File Code: 1950
Date: August 9, 2019

Purpose: This merger meeting was scheduled to gain concurrence on Concurrence Point (CP) 1 (Purpose and Need and Study Area Defined), CP 2 (Detailed Study Alternatives Carried Forward), and CP2A (Bridging Decisions).

STIP Project Number: A-0009C

STIP Description: Corridor K Improvements along US 129, NC 143, and NC 28 from Robbinsville to Stecoah

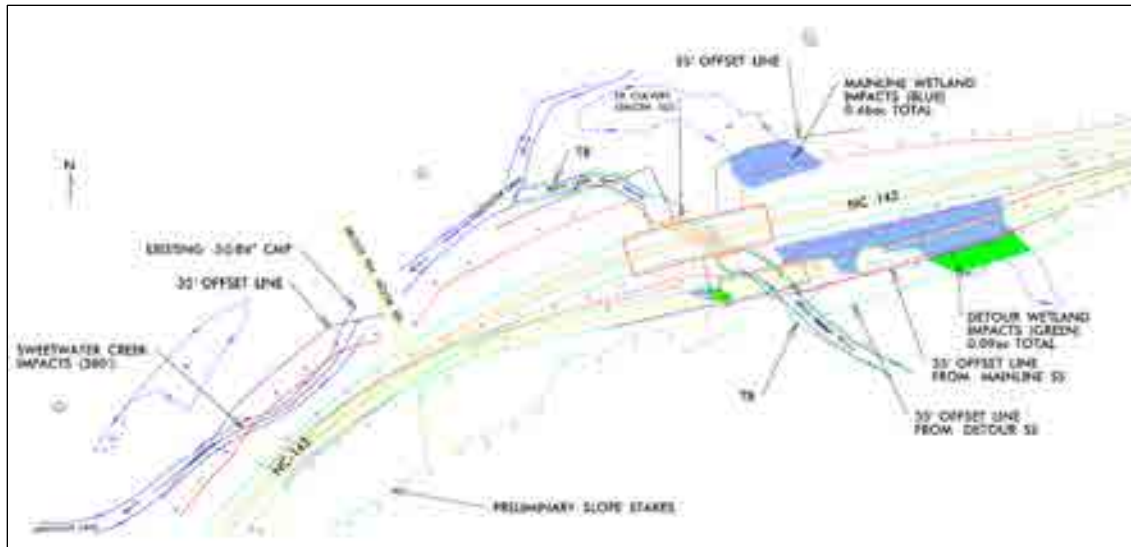
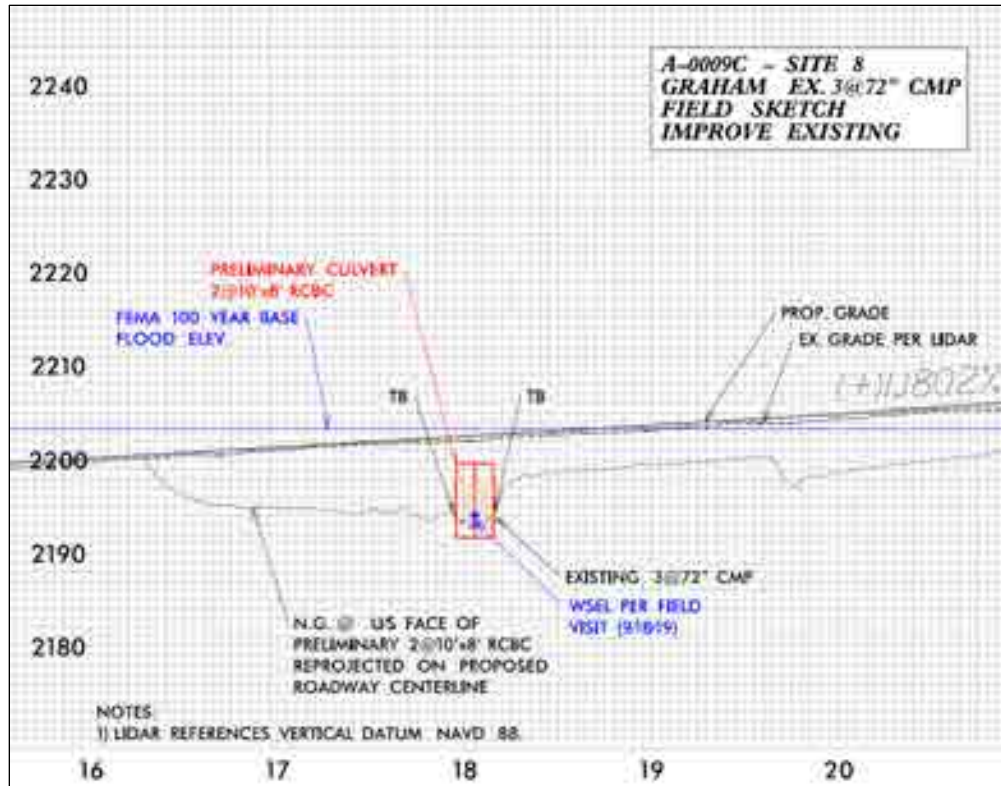
- Slide 12, USACE inquired about the symbology.
 - TGS Hydraulics noted that the red and green dashed lines represented the slope stakes, while the maroon line represented the slope stakes plus 35-ft.

- USACE inquired about why the grade would need to be raised and whether this was due to floodplain requirement.
 - TGS Hydraulics noted per NCDOT guidance, the grade would need to be raised in order to achieve minimum freeboard (clearance between the water surface and bridge) allowing the bridge to be useable in the event of a 50-year flood. If the existing grade was maintained, the low chord of the bridge would be sitting close to the ground and would not convey the 50-year flow.

- USACE requested schematics (showing banks, waterlines, bridge/culvert, surface water elevation) for the bridge and culvert designs to see where the base of the channel is with regards to the top of bank floodplain. The schematics do not need to be detailed to CP 4B level.

Post Meeting Schematic: Site 8 Culvert Option

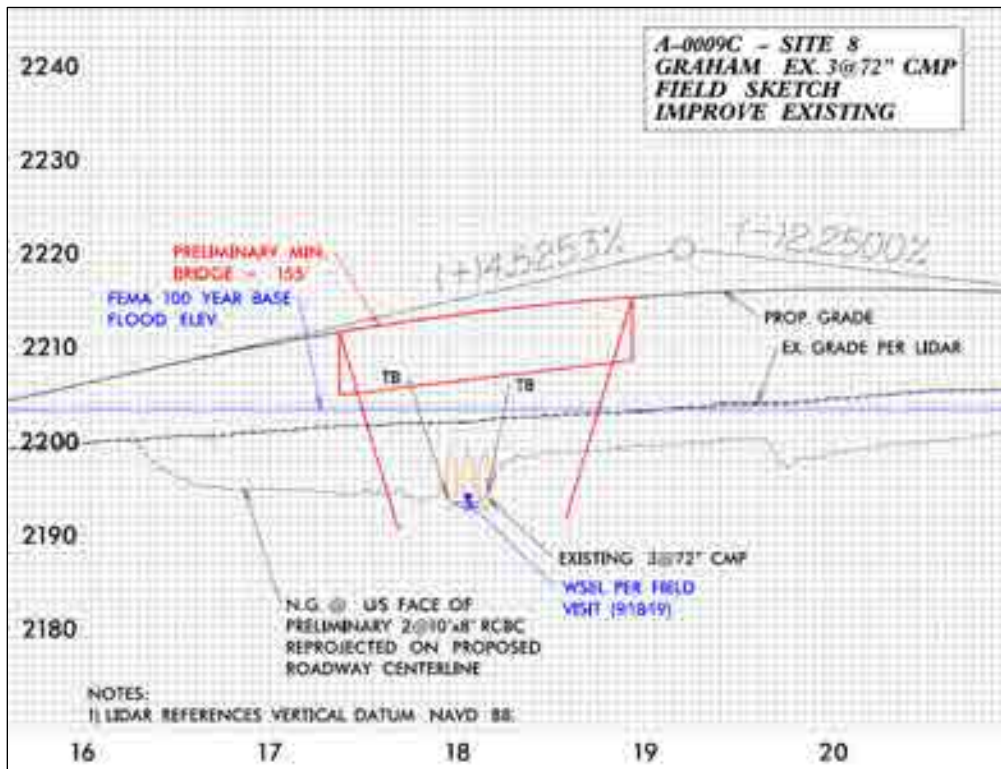
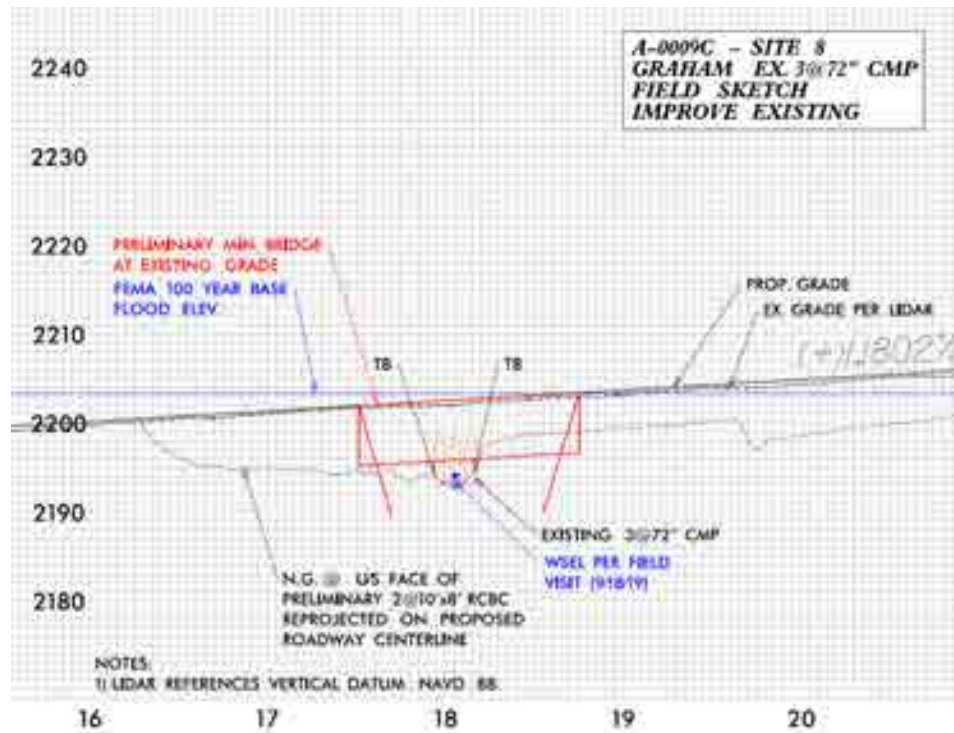
- North Carolina Division of Water Resources (NCDWR) inquired about the permanent impacts of a bridge that would require mitigation.
 - TGS Hydraulics noted there would only be parallel stream impacts to Sweetwater Creek associated with the bridge option.

- USACE inquired if a bridge could be stage constructed.
 - Division 14 noted that due to the grade difference, it would not be possible to stage construct the bridge.
- North Carolina Wildlife Resources Commission (NCWRC) inquired if there were other engineering options such as a smaller or lower bridge not constrained by FEMA regulations that may require a design exception.
 - Division 14 noted that if the bridge was lower, it would not provide the required capacity of flow. In order for water to pass, the grade would need to be raised.

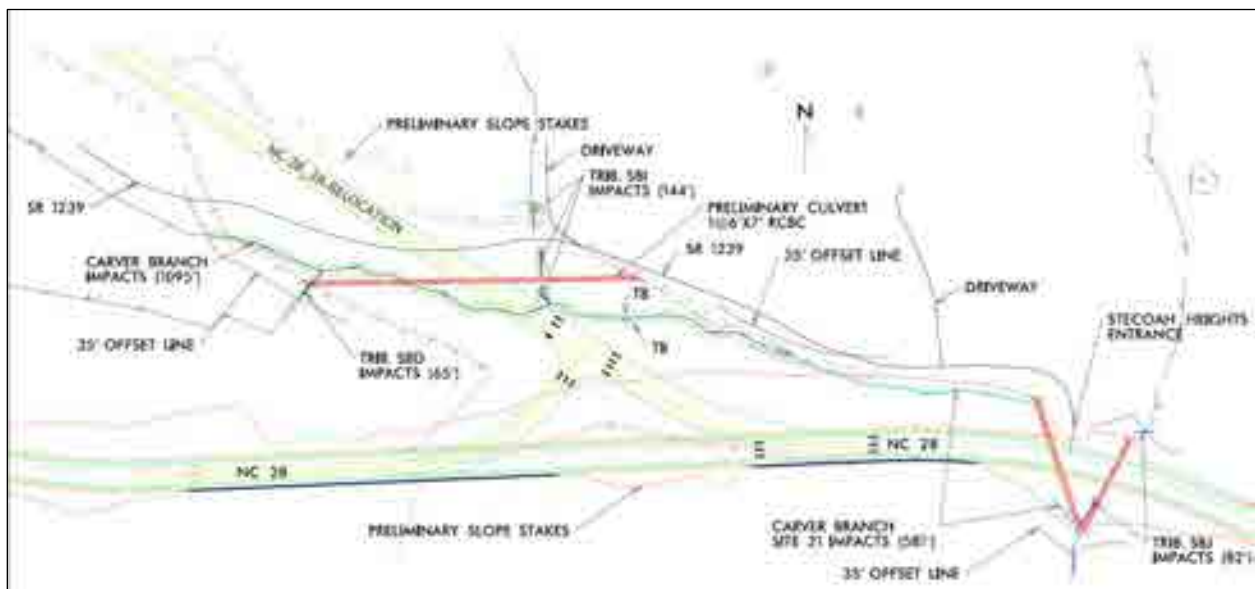
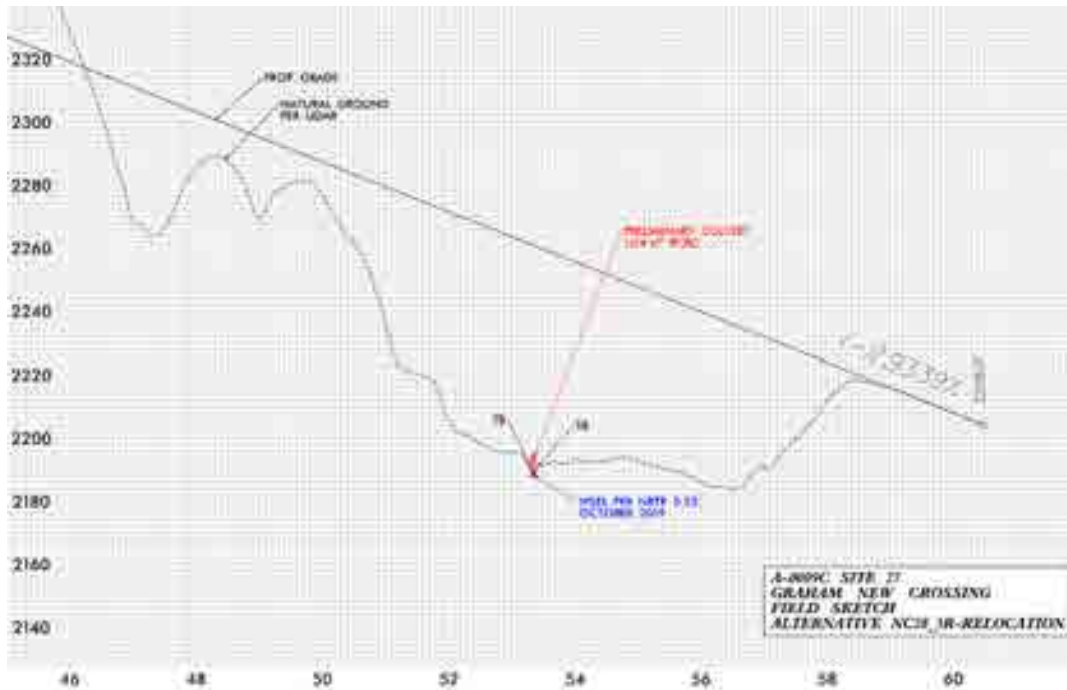
- NCWRC noted that the culvert option is unacceptable to them as the length and grade is unlikely to allow for fish passage. NCWRC requested additional information and discussion on the NC 28 relocation and what the outcome would be if the existing road is not relocated.
 - TGS Hydraulics noted there are culverts with similar slopes on I-26 that allow for fish passage.

- USACE agreed neither a bridge nor culvert is desirable, but a bridge appears unfeasible from a design standpoint. A final decision is not being made at this point.

Design Option S-2: Previous footprint shown in turquoise; current footprint shown in green

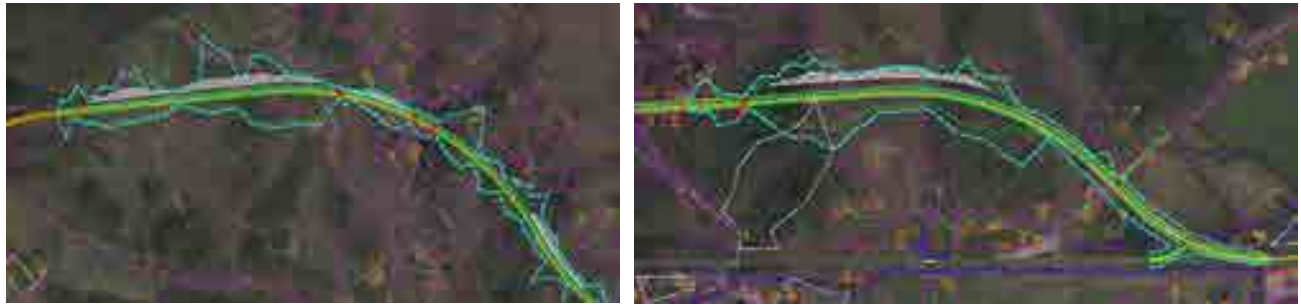
Design Option S-2: Stantec reviewed changes between the current and previous S-2 designs, which now have incorporated geotechnical scoping recommendations. Environmental features and archaeological information to date were presented.
